PRODUCT CHANGE NOTIFICATION

Date: November 06, 2015
PCN: PCN LEDIL 112 b

Subject: PCN 112.b – Change of product mechanical design

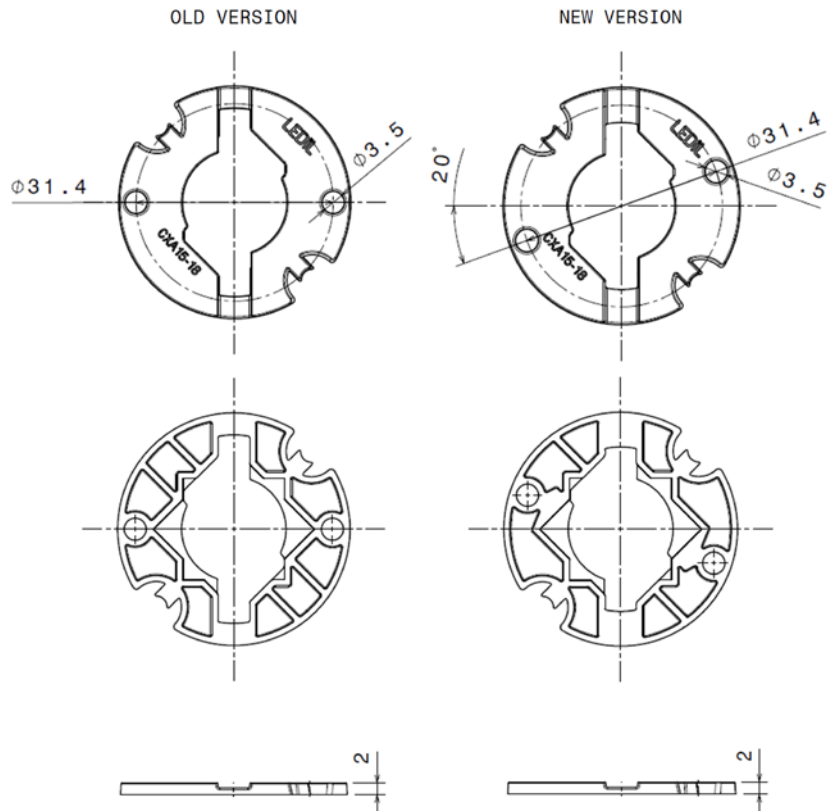
Description: As part of our continuous improvement process regarding the quality of our products LEDiL has moved the screw holes in C14305_STELLA-CLAMP-CXA15-18 to improve mechanical functioning between different COB versions.

Changes: Screw hole positions have been changed accordingly.
